[Docket No. FAA-2014-0337; Directorate Identifier 2013-SW-029-AD]

Airworthiness Directives; Various Restricted Category Helicopters

ACTION: Notice of proposed rulemaking (NPRM).

Various Restricted Category Helicopters:

Figure 1 to Paragraph (f)

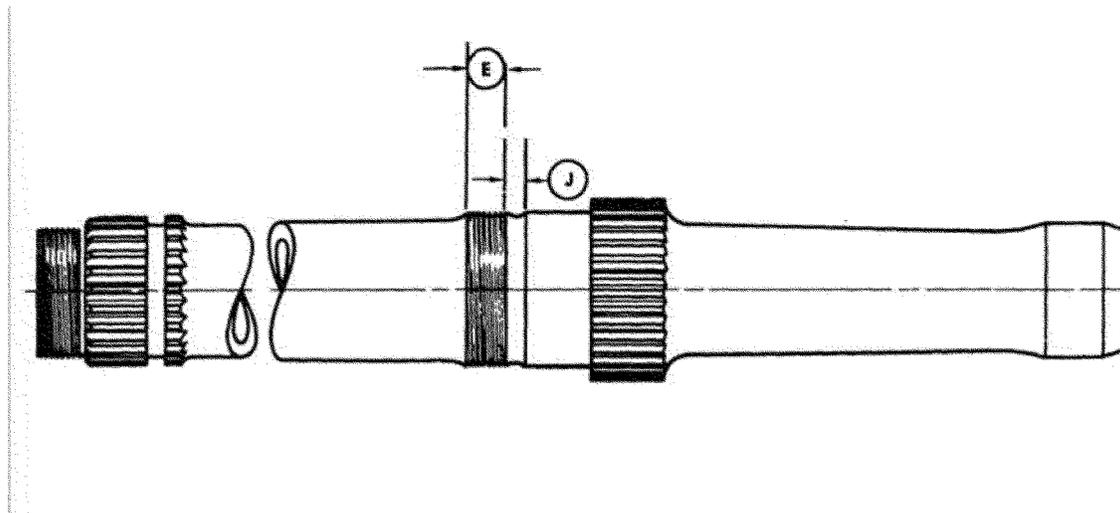
The National Transportation Safety Board (NTSB) commented in support of the required inspection of the threaded area of the mast for a crack, pitting, or corrosion, but requested that the area adjacent to the threaded area (identified in AD 2012–14–11 as “area J”) be added

to the visual inspection requirements of the proposed AD. The NTSB states that a prior accident investigation revealed the mast had fractured in this section. We agree with this comment. Although AD 2012–14–11 does contain a requirement for magnetic particle inspecting the entire mast for a crack, we have included the expanded area in the visual inspection requirements in the proposed AD.

- (i) Remove any surface rust with a wire brush or steel wool and, using a 10X or higher power magnifying glass, inspect the areas of the mast as shown in area E and area J of Figure 1 to Paragraph (f) of this AD for pitting, corrosion, or a crack.
- (ii) Overhaul the main rotor mast assembly and magnetic particle inspect the mast; mast bearing nut; plate, mast and seal; and bearing liner for a crack.
- (iii) Fluorescent penetrant inspect the locking plate for a crack.

(2) If there is a crack, pitting, or corrosion, before further flight, replace the mast with an airworthy mast.
